# **Report to Development Permit Panel**

DP 19-864104

Re: Application by Eric Stine Architect Inc. for a Development Permit at 8600, 8620,

8640 and 8660 Francis Road

# ACCESSIBLE (CONVERTIBLE) UNITS 1 & 10

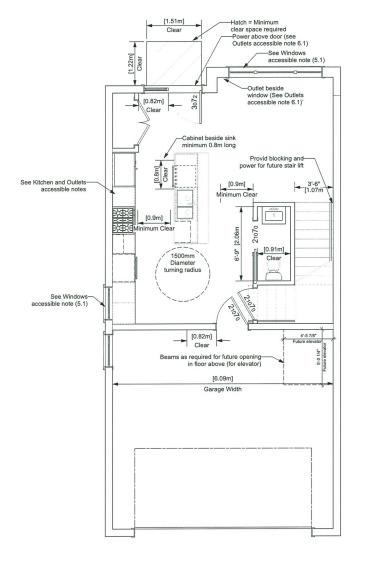
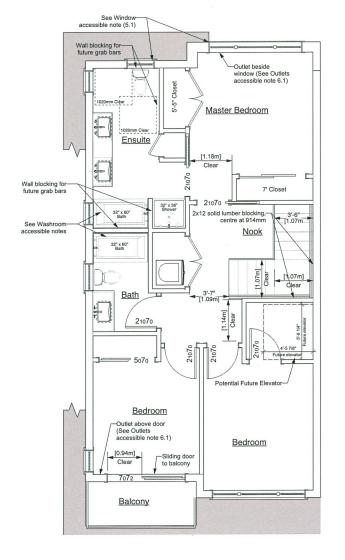
- appreciate the provision of two convertible units in the project;
- design of convertible unit ground floor access from the garage is supported;
   however, exit to the garage could be widened to open the door for a person in a wheelchair;

consider a pocket door or outward swinging door in lieu of an inward swinging door for the powder room on the ground floor of the convertible unit to enhance its accessibility;

appreciate the second floor ensuite design for the convertible unit; consider an outward swinging door for the walk-in closet and a pocket door for the second bathroom to enhance their usability and accessibility;

Response: Layout revised to have clear space beside the door to garage.

Response: Powder room door revised to be a pocket door.

Response: Layout revised to eliminate walk-in closet. A standard closet with sliding door is provided, to increase accessibility. Pocket doors are now being used of entry door to bedroom and ensuite.
